# Harvard Avenue - Proposed New Residential Construction Project (SDCI #3025137)

SEATTLE DESIGN REVIEW

July 19, 2017 | Recommendation Meeting

# MASSING OVERVIEW

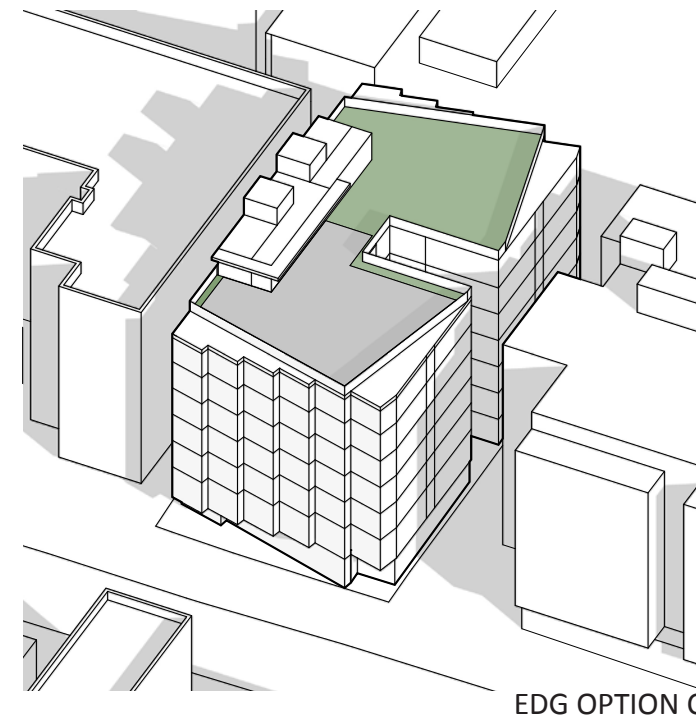
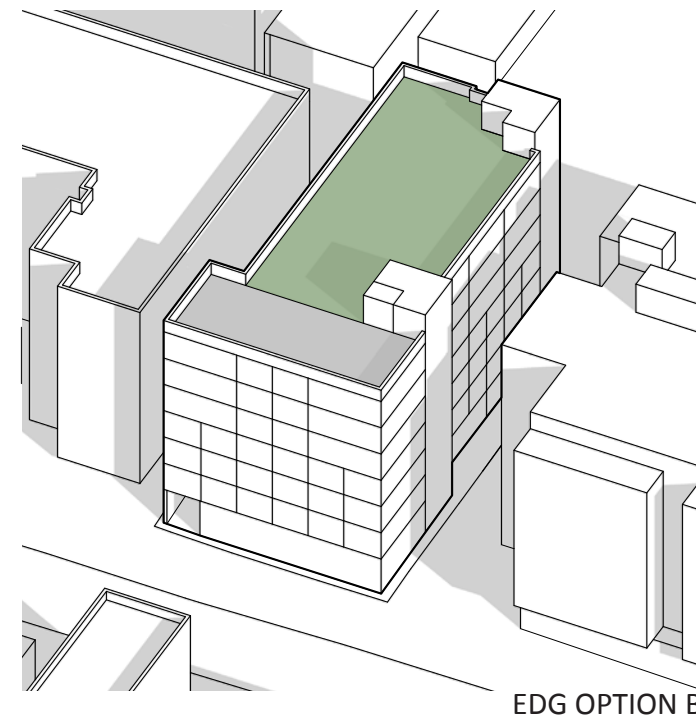
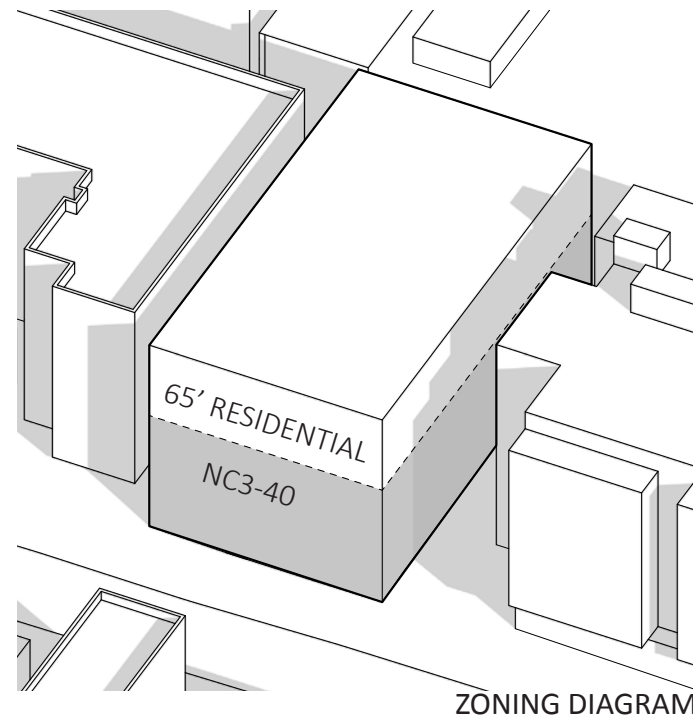
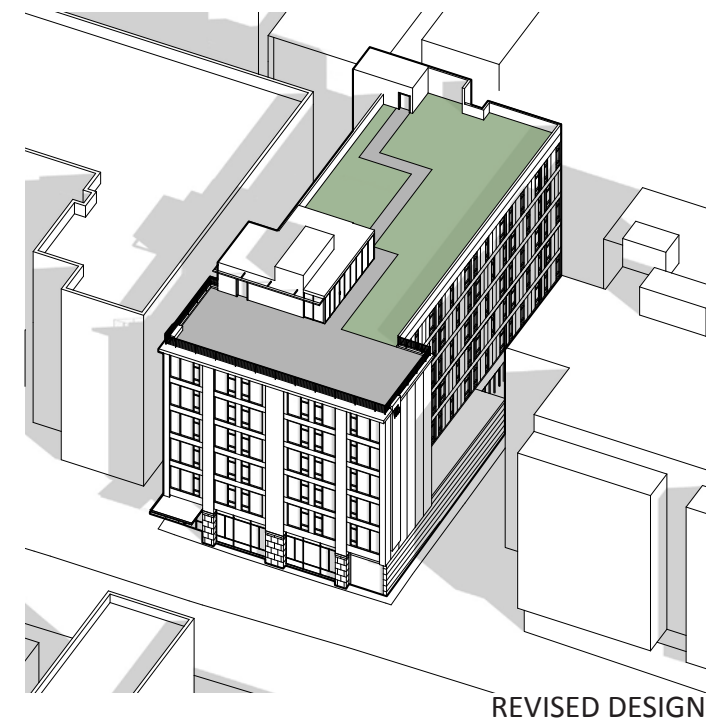
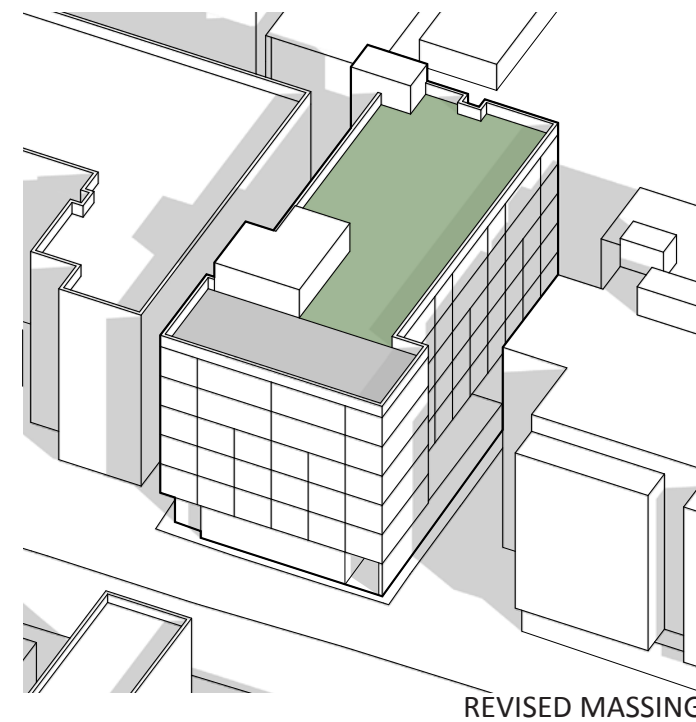
BOARD FELT SAWTOOTH DESIGN DID NOT RELATE TO OVERALL DESIGN

- PROS
- VOLUNTARY SETBACKS ALLOW FOR MORE DAYLIGHT AND NATURAL VENTILATION
  - SETBACKS ALLOW PLANTING AT NORTH AND SOUTH EDGE OF BUILDING
  - STRONG FACADE HELPS REINFORCE STREET EDGE
  - PARKING GARAGE ENTRANCE AT SOUTH MINIMIZES PEDESTRIAN CONFLICT
  - REDUCED CURB CUT WIDTH MAXIMIZES PEDESTRIAN ZONE

# HEIGHT, BULK, SCALE - SETBACKS

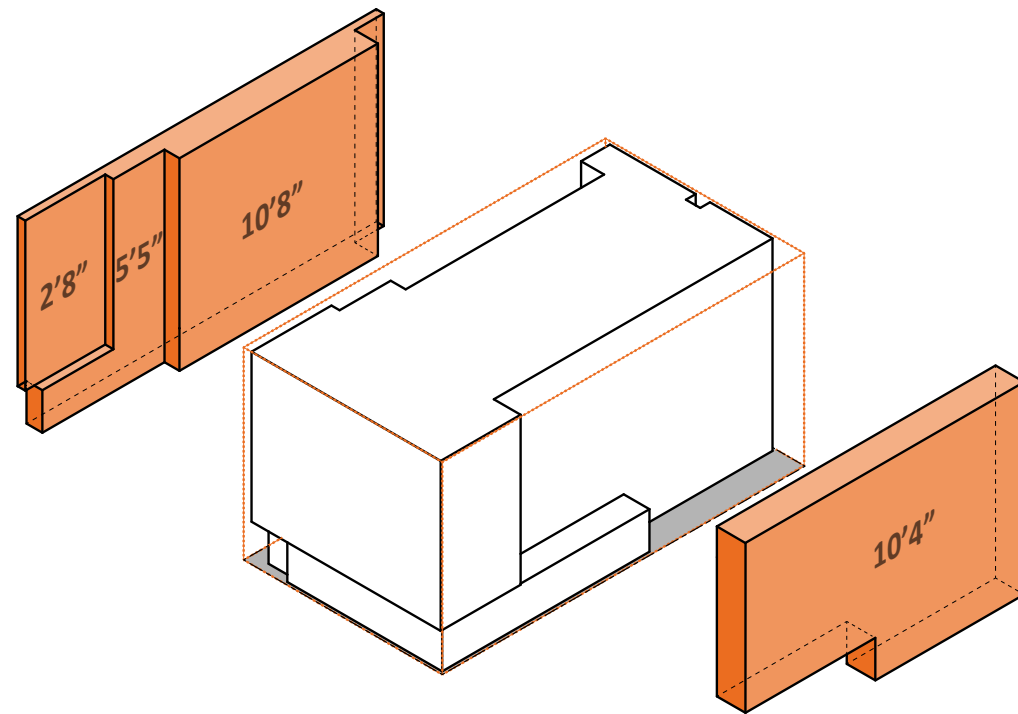
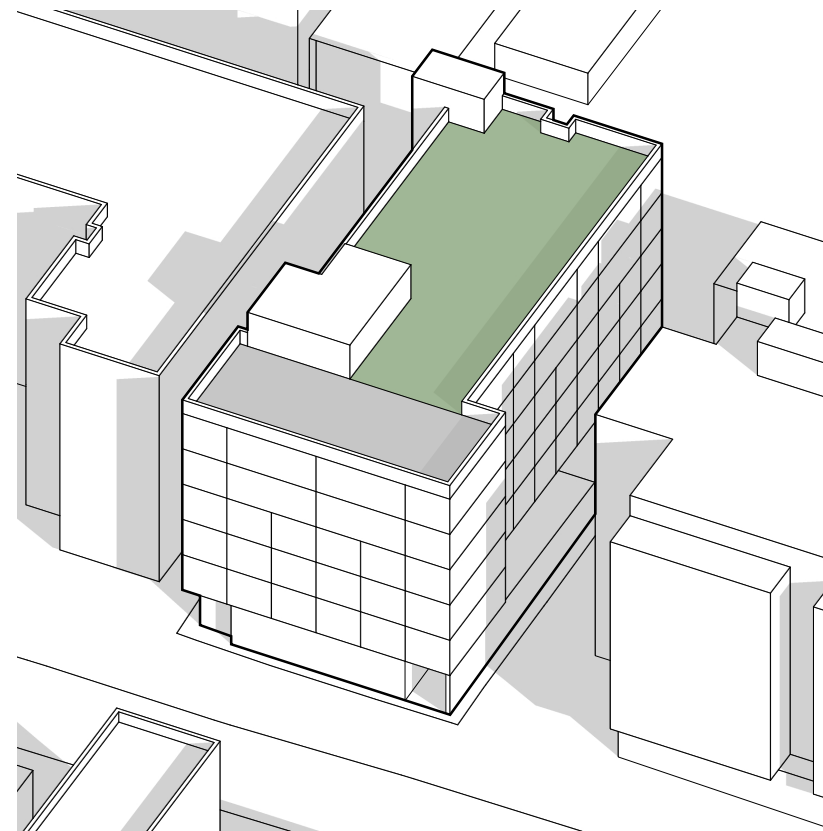
- The board recommended an increased north setback to provide relief for the Pantages Apartments.
- The board suggested an increased southern setback would help with access to light and fresh air for residents.
- The board favored design Option B

The building has been setback between 2'-8" to 10'-8" from the North property line. This setback provides the Pantages with sunlight and natural ventilation and will be planted with native plant species and other vegetation to create a natural buffer. Additional articulation has been incorporated to provide privacy to the neighboring apartment, break up the depth of the facade, and add interest. (CS1-B, CS1-D, CS2-B, CS2-D, PL3-B, DC2-B, DC2-C, DC3-A)

# NORTH SETBACK

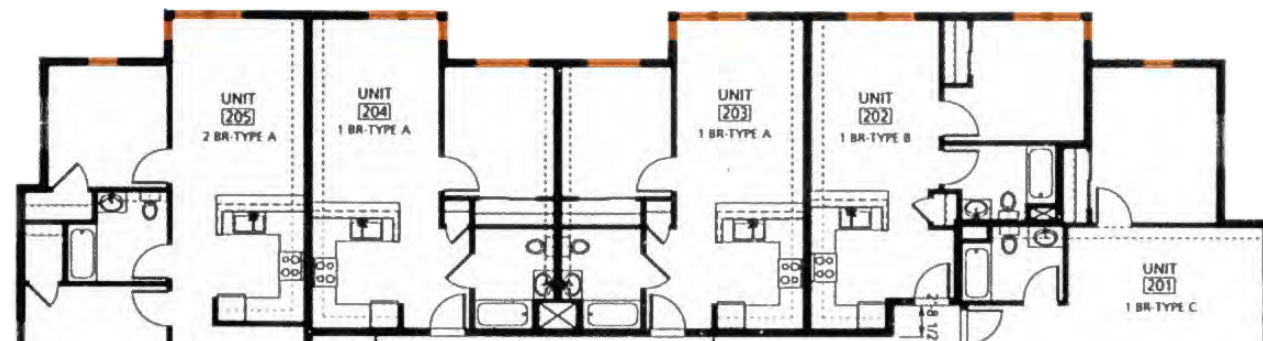
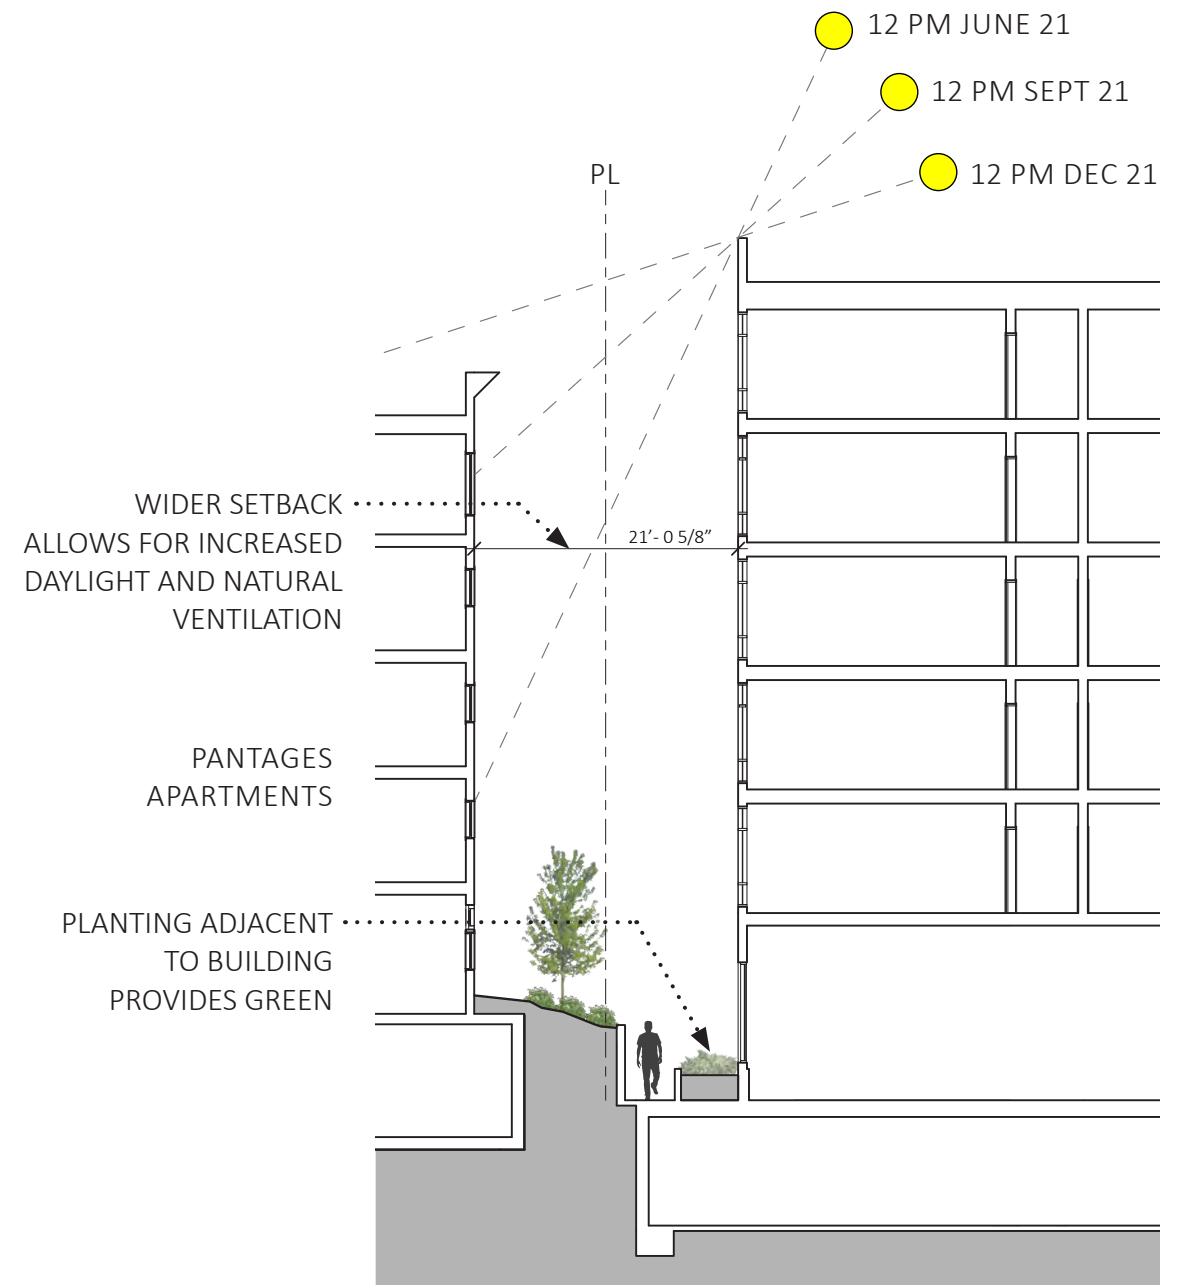
- The board recommended an increased north setback to provide relief for the Pantages Apartments.

The building has been setback between 2'-8" to 10'-8" from the North property line. This setback provides the Pantages with sunlight and natural ventilation and will be planted with native plant species and other vegetation to create a natural buffer. Additional articulation has been incorporated to provide privacy to the neighboring apartment, break up the depth of the facade, and add interest. (CS1-B, CS1-D, CS2-B, CS2-D, PL3-B, DC2-B, DC2-C, DC3-A)

# SOUTH/EAST SETBACK

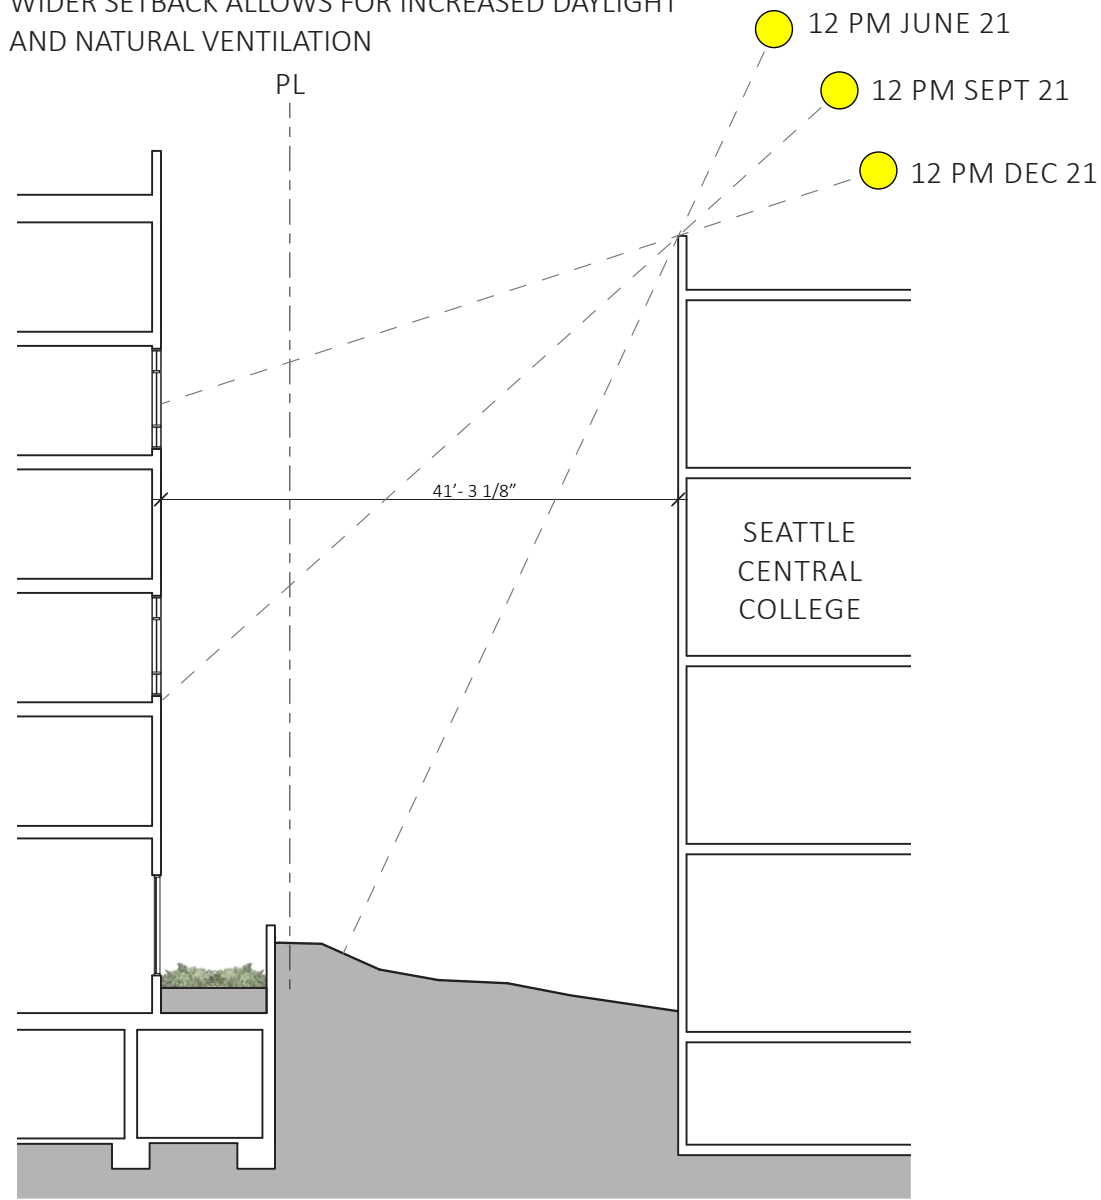
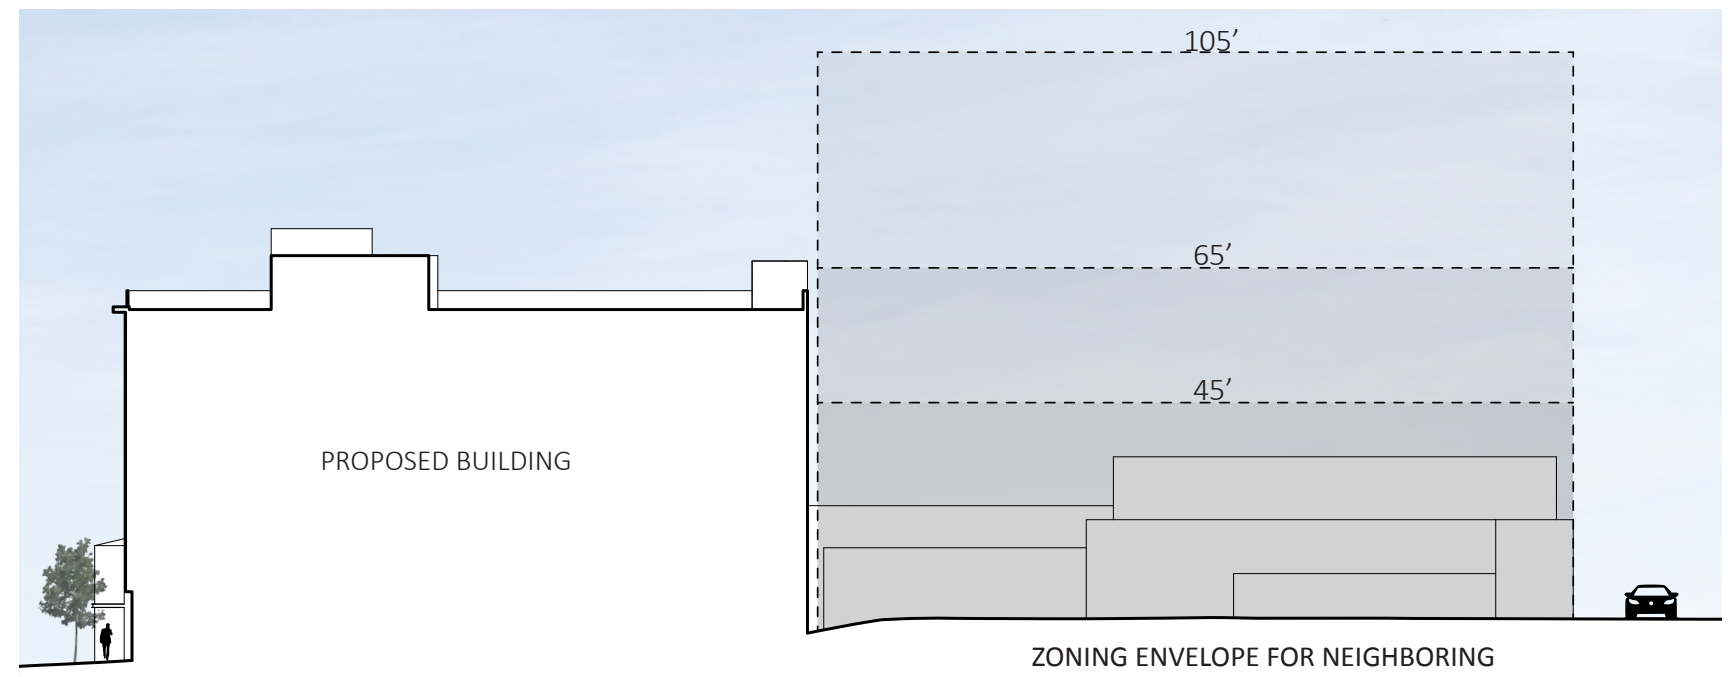
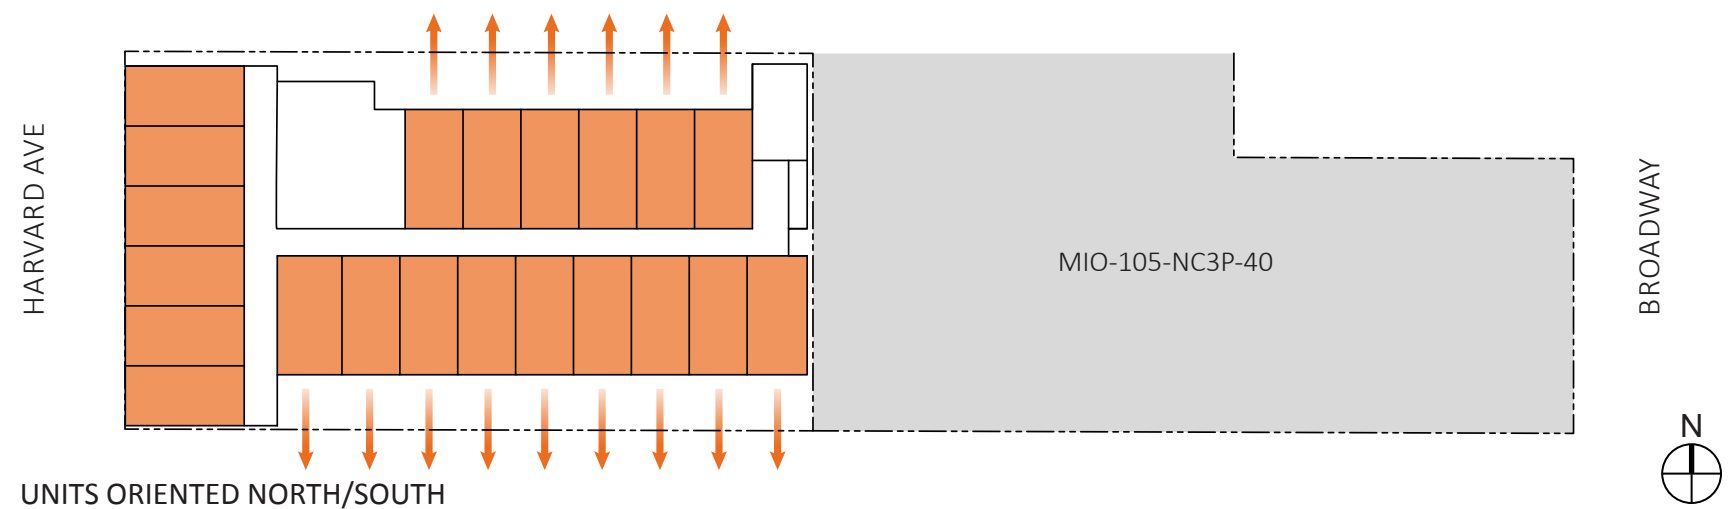
- The board requested a larger southern setback would help with access to light and air for residents of the proposed project in relation to the Seattle Central building.
- The board suggested responding to the future context of a taller transit oriented development adjacent to the east, which could impact residents of the applicant's project.

The massing has been revised to provide a larger southern setback to provide space for air and sunlight and views of landscaping at grade level. The massing has been revised to anticipate a larger building to the east and shifted the views of the units to face the more open spaces to the north and south. (CS1-B, CS1-D, CS2-B, CS2-D)
